# CITY OF ALBUQUERQUE

**Re: 2900 Central Project/ 2900 Central Ave SE**  
**Request for Certificate of Occupancy**  
**Transportation Development Final Inspection**  
Engineer's Stamp dated 02-01-24 (K16D009A)  
Certification dated 02-09-26  
TRANS-2025-00343

**TCL1**

**A1 TRAFFIC CIRCULATION LAYOUT**  
 1"=10'-0"

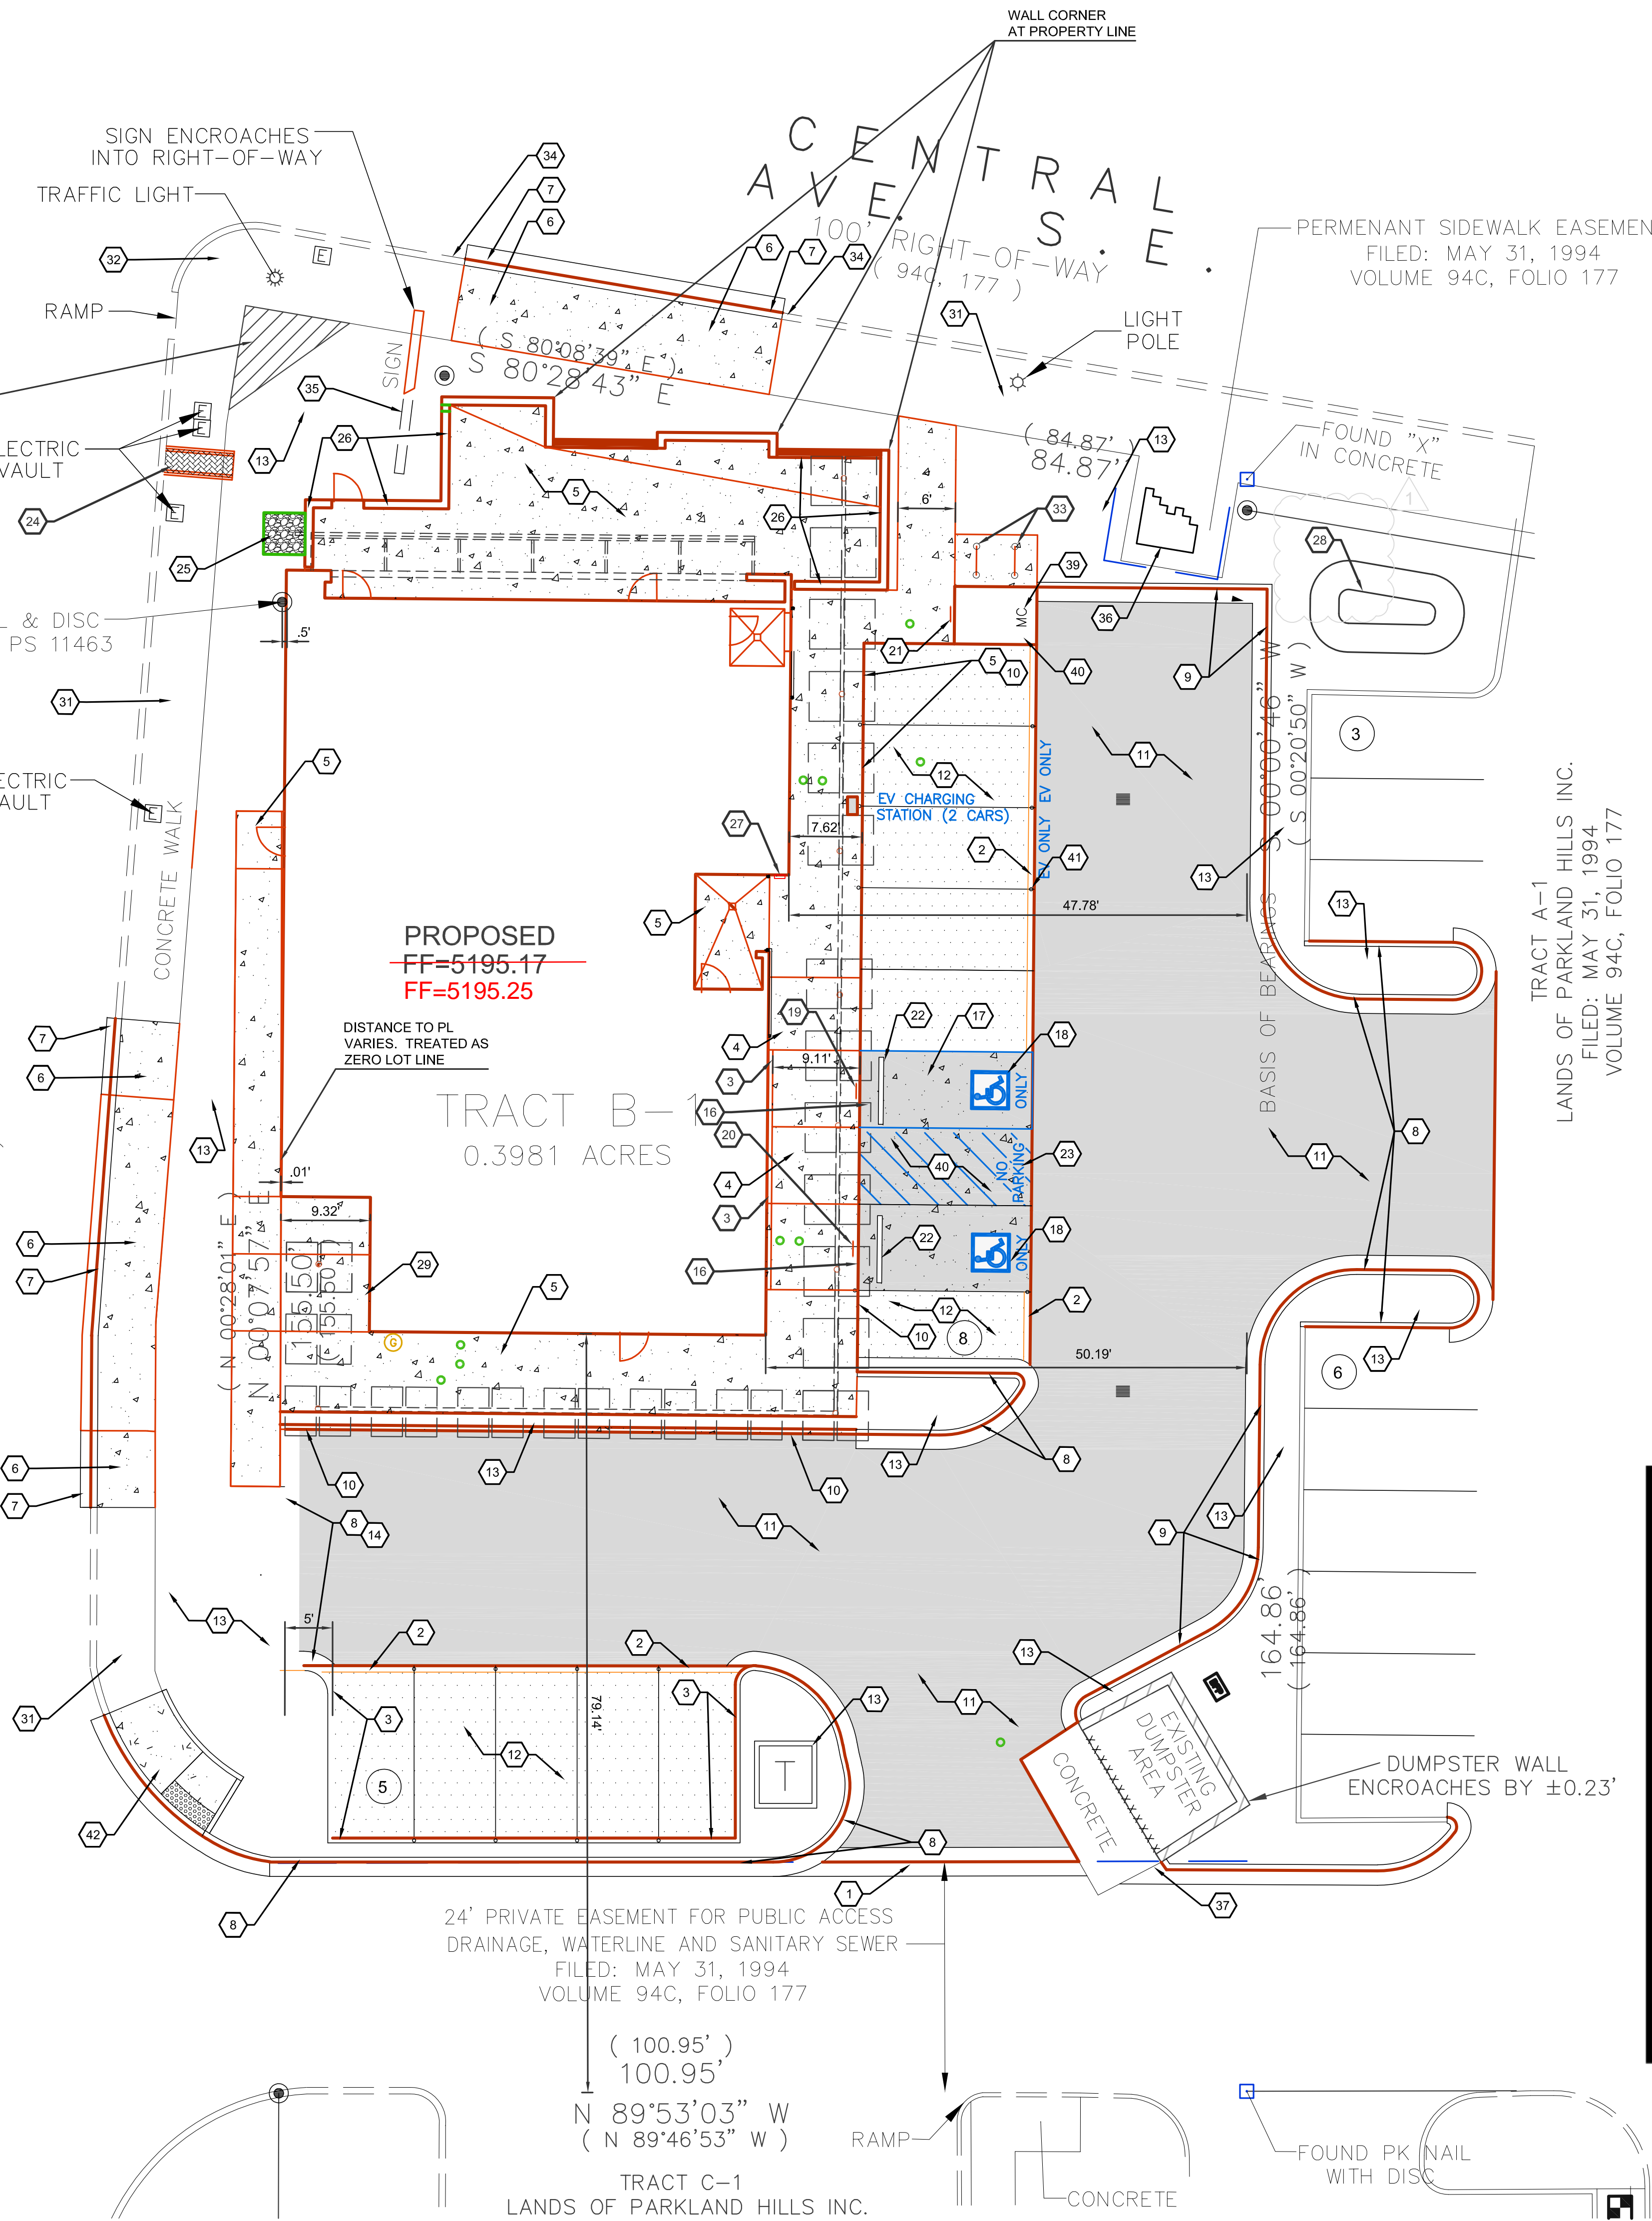
This plan reflects revisions to the location of the Accessible Parking and corrections to the bike rack.

All broken or cracked sidewalk must be replaced with sidewalk and curb & gutter. A build note must be provided referring to the appropriate City Standard drawing

Landscaping and signage will not interfere with clear sight requirements. Therefore, signs, walls, trees, and shrubbery between 3 and 8 feet tall (as measured from the gutter pan) will not be acceptable in the clear sight triangle
